## BLMM Bridges

CE 383S: Prestressed Concrete Bridges

Final Design Project

May 04, 2006

Figure 6: Arch Bridge preliminary sketch

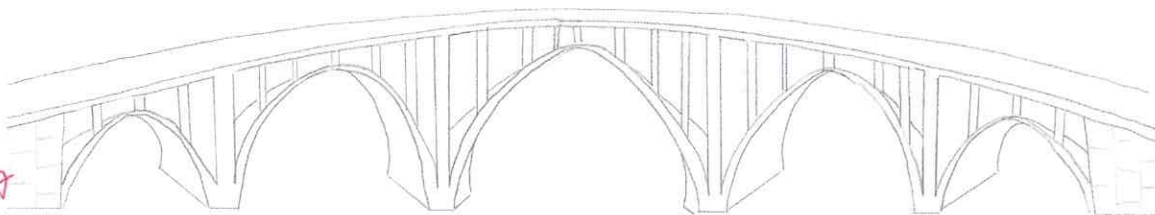
where is cost of this 100' of full and retaining wall ✓

Figure 8: Kite Bridge geometry

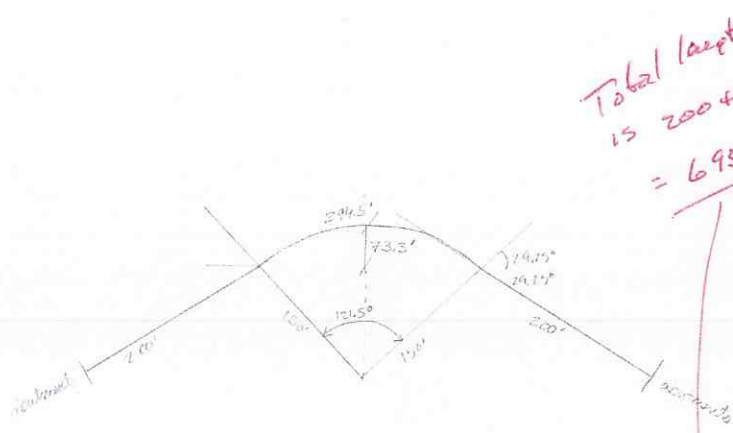
*Very sketchy but catchy*

Need much  
heavier line  
weights and  
the more legible  
font

Figure 9: Kite Swing Bridge preliminary superstructure geometry design

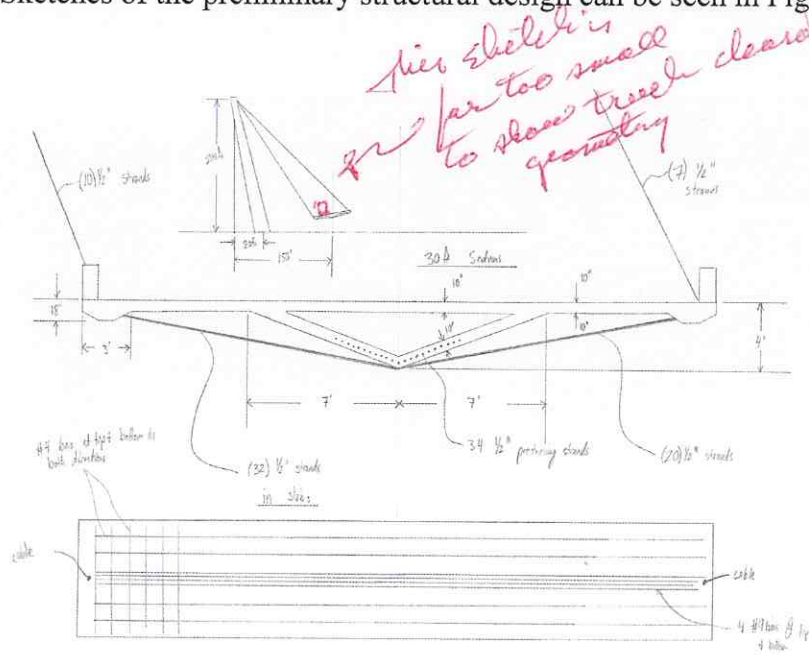
ties sketch is  
far too small  
to show true  
geometry

Figure 10: Kite Swing Bridge preliminary pylon design

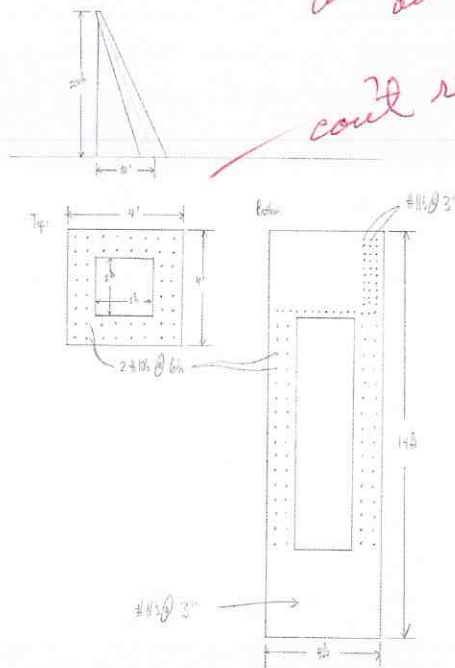
width would 120' across  
road at min vent clearance  
how do you get  $18' + 4' = 22'$   
up in  $\frac{695 - 120}{2} \approx 288'$   
that's over an 8% grade  
you do not have any  
cuts for approach fills,  
retaining walls, etc

*ways too small and faint  
could reveal dimensions here*

SUPERSTRUCTURE SECTION CROSS-SECTION VIEW (UNITS IN INCHES)

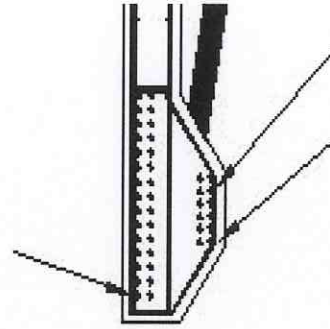
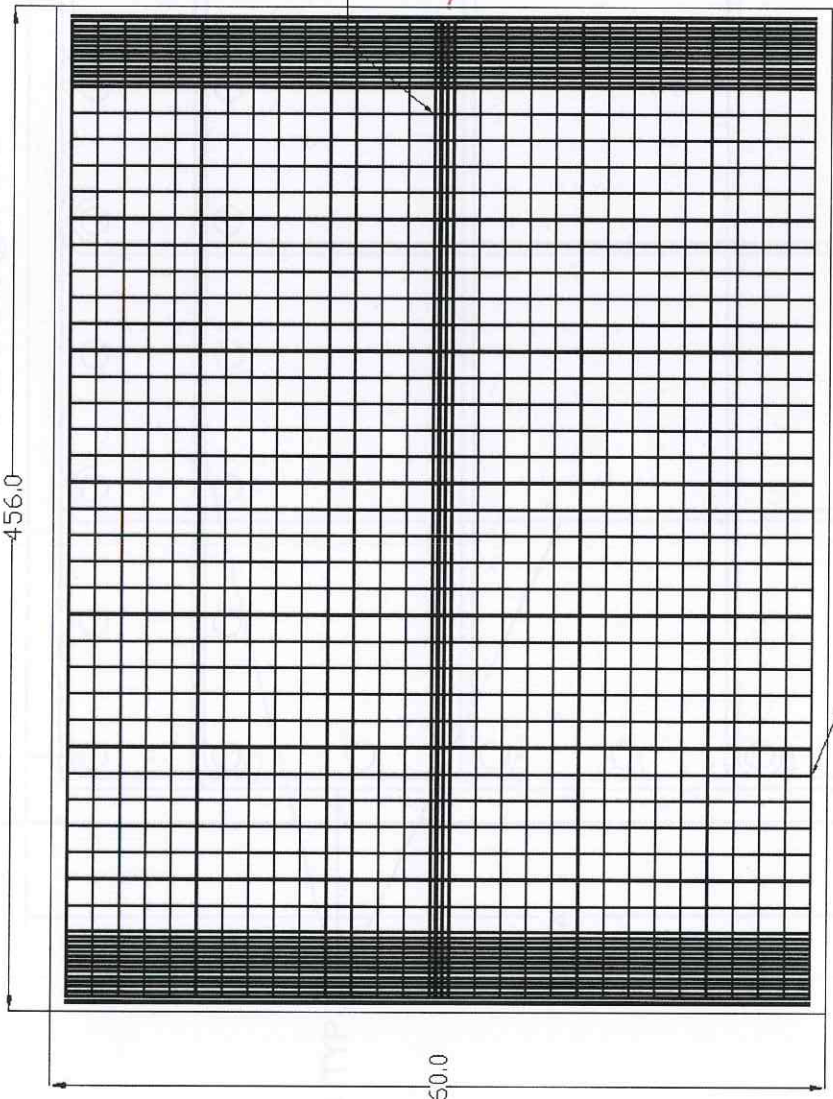
*How are stays connected?*

*where is detail of stay connection?*

PYLON (TOP SECTION VIEW)

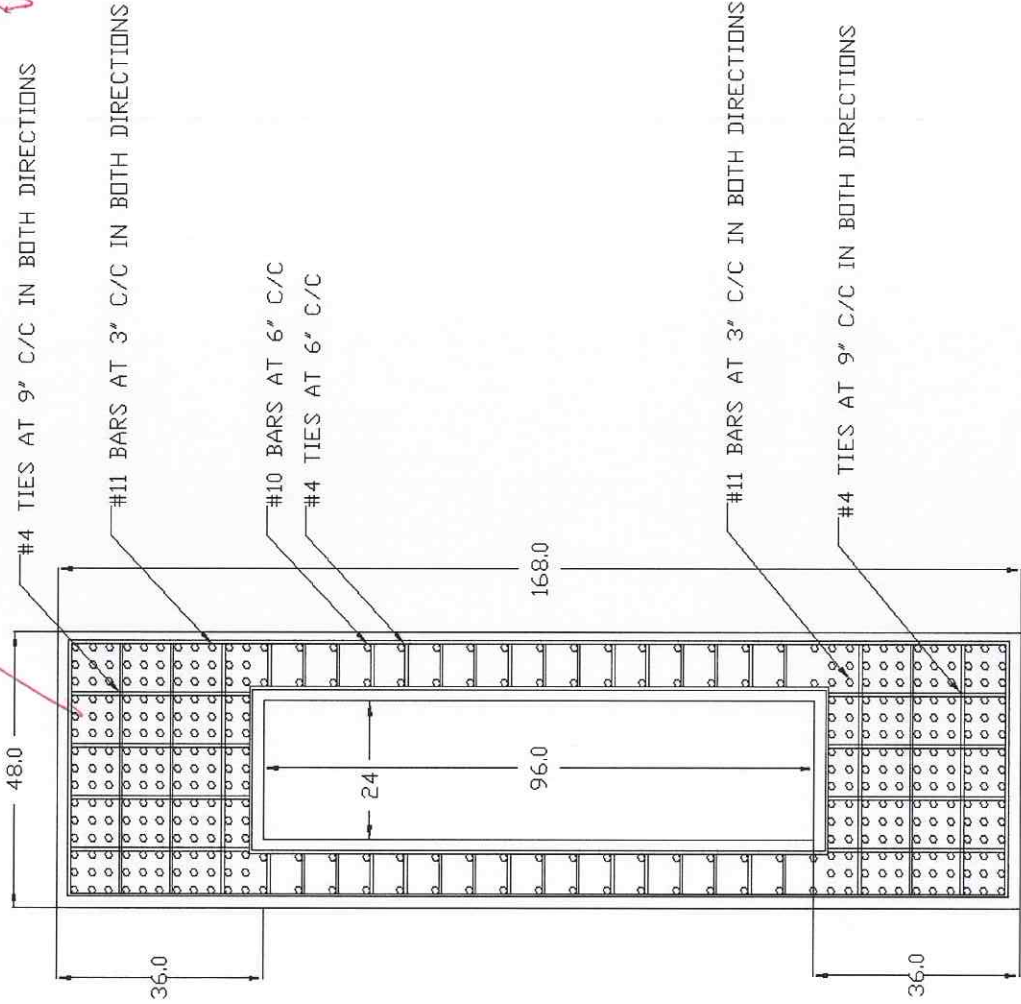
*How does connection between superstructure units work?  
what type of joints are bars spliced etc*

ARCH PRELIMINARY

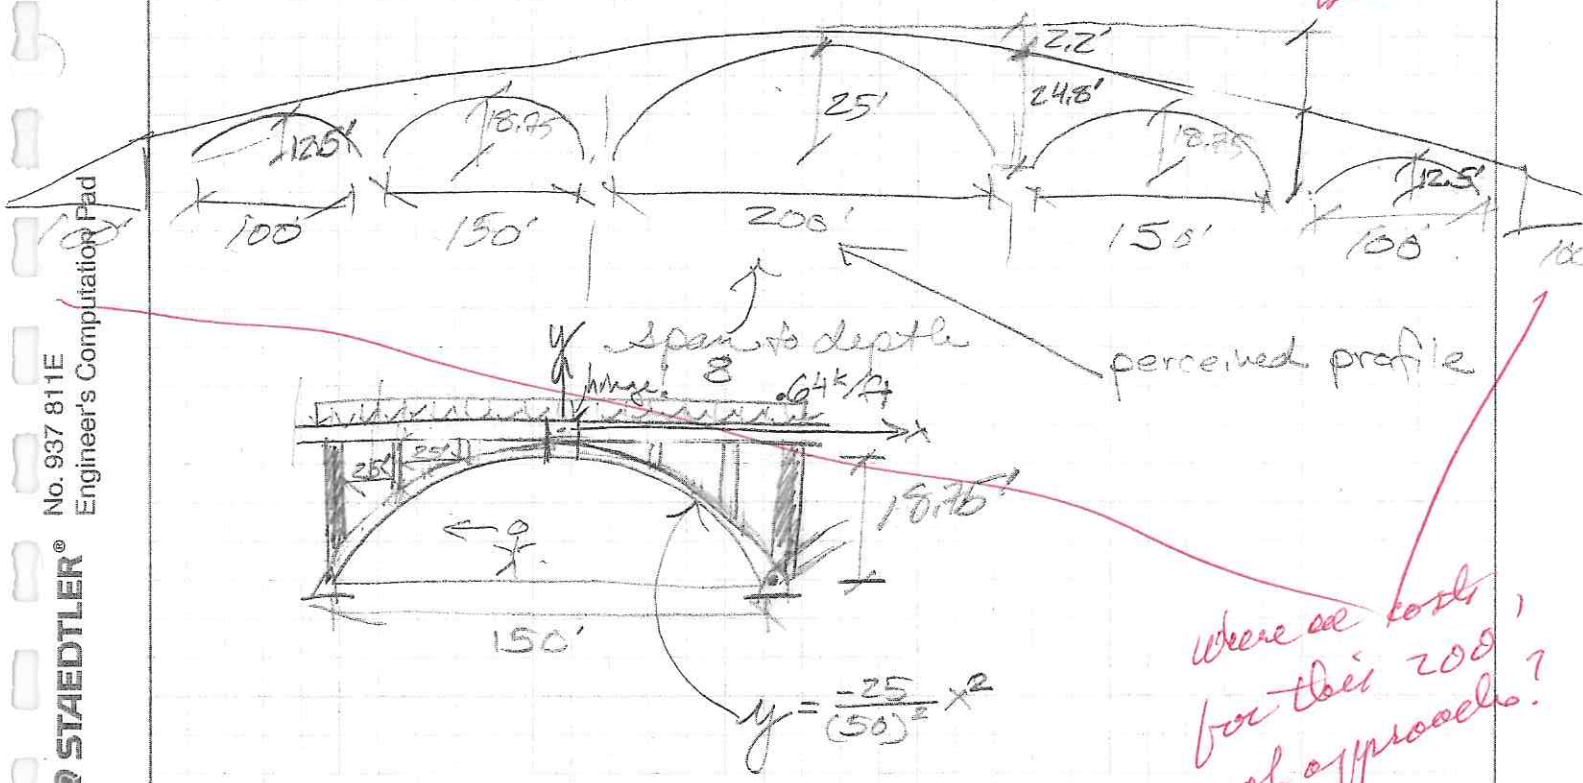
where are costs for this 200' of approach?

Plan

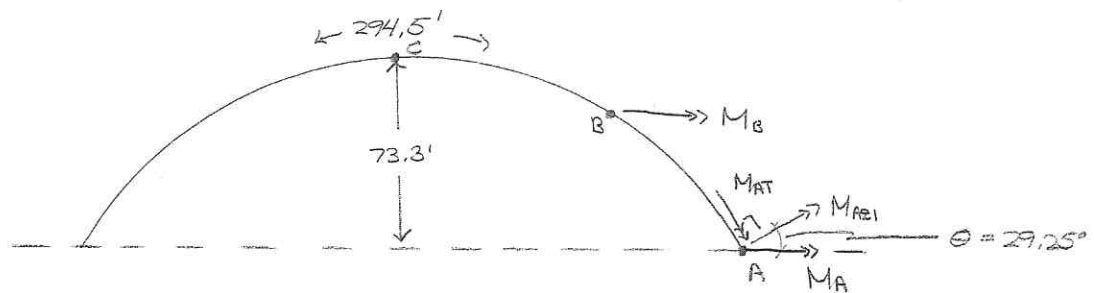
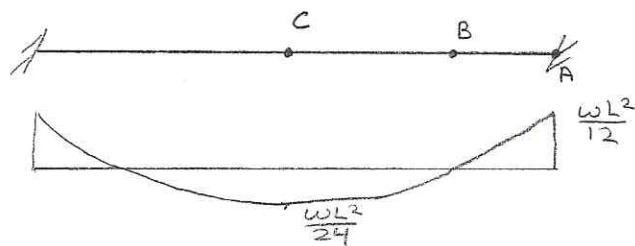
*To you want something like this -- why not design as arch instead of 300' span beam - Doesn't make much sense to me*

Pre-Preliminary Bridge Concepts

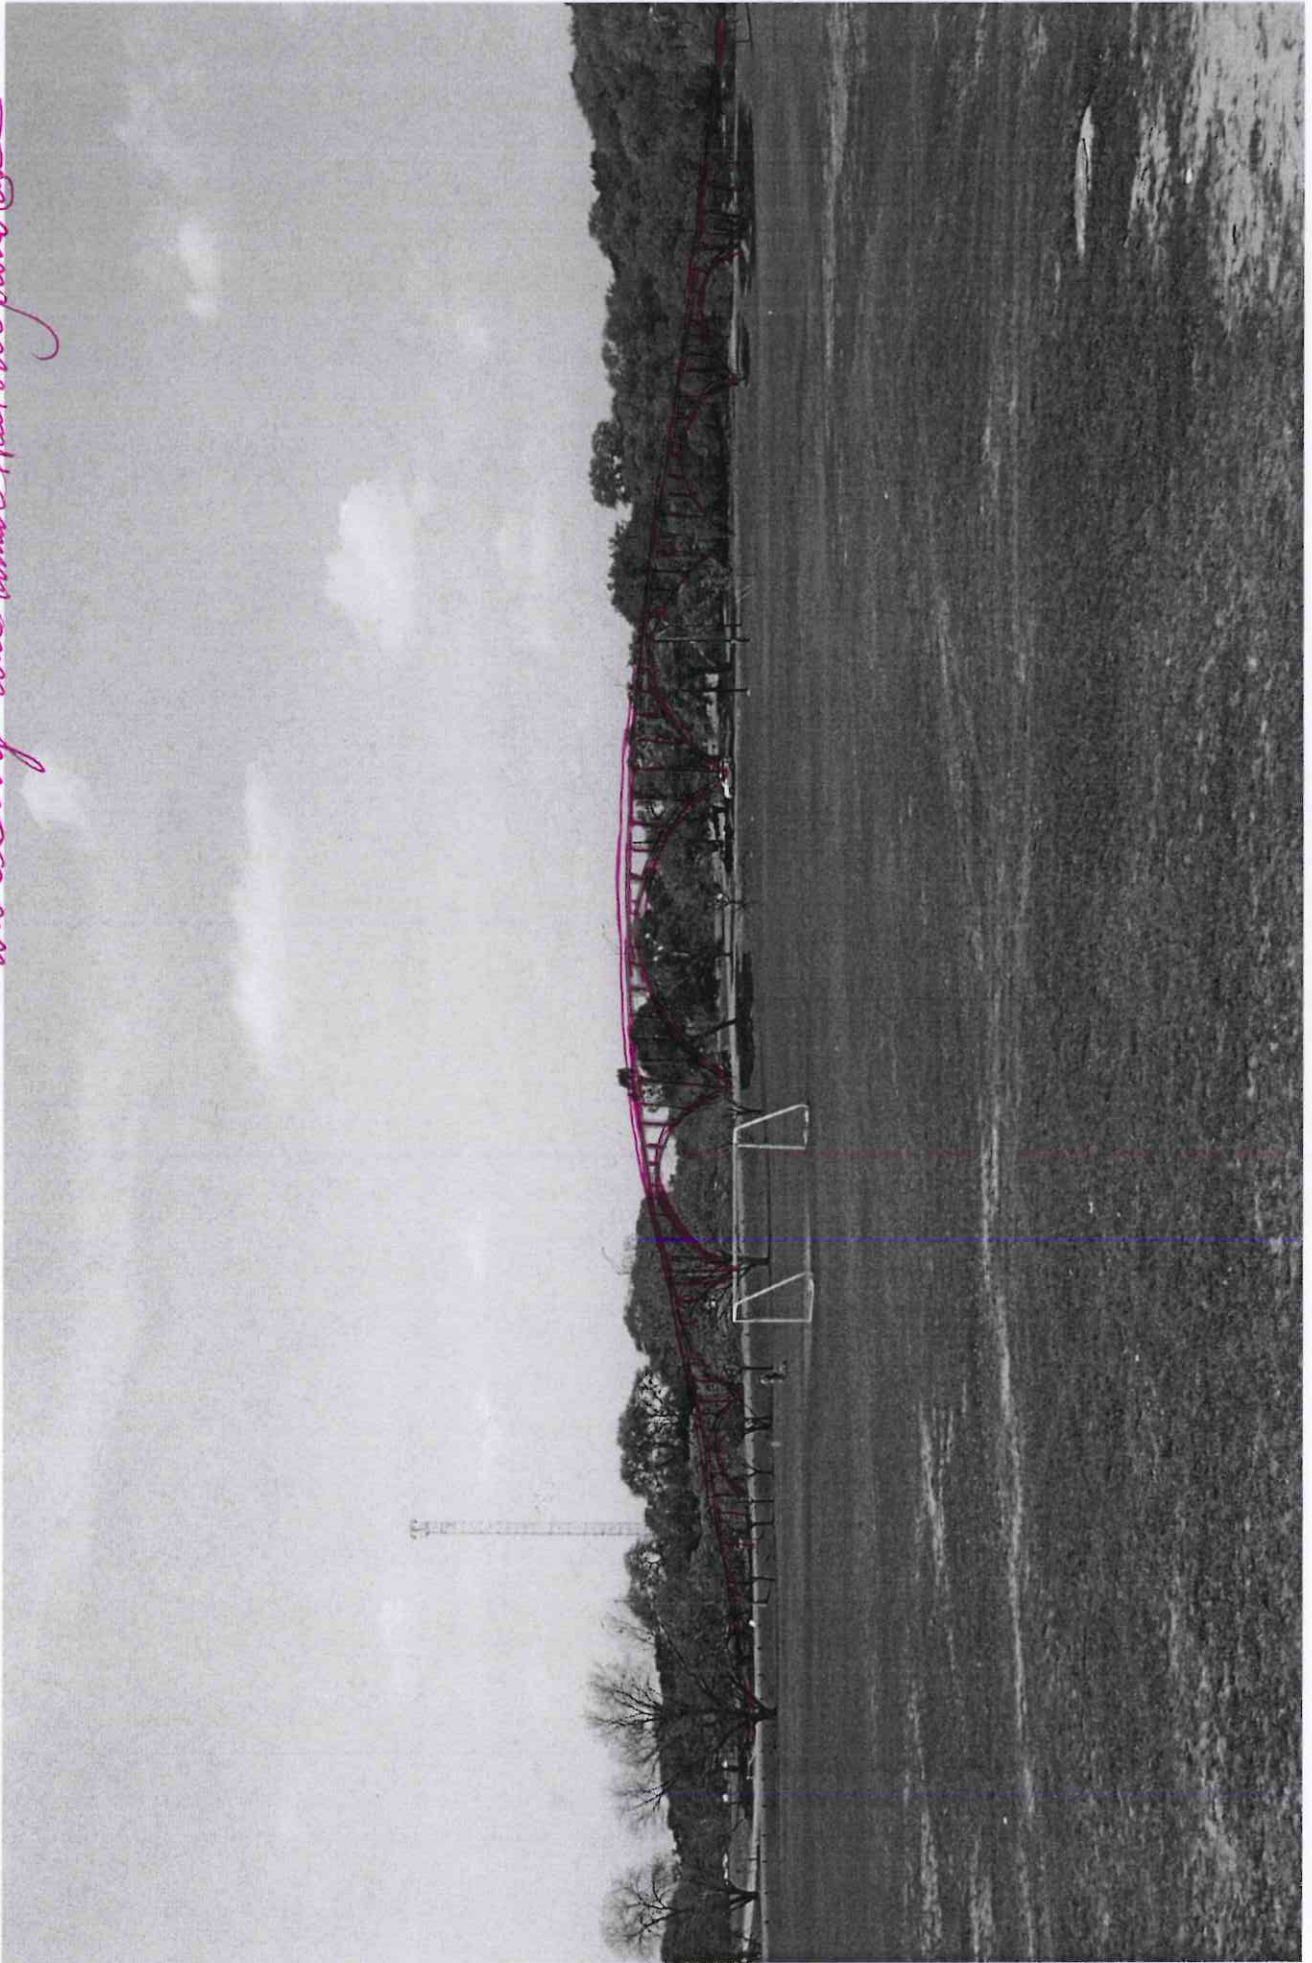
*These are good  
but where is  
Kite Swing Bridge?*
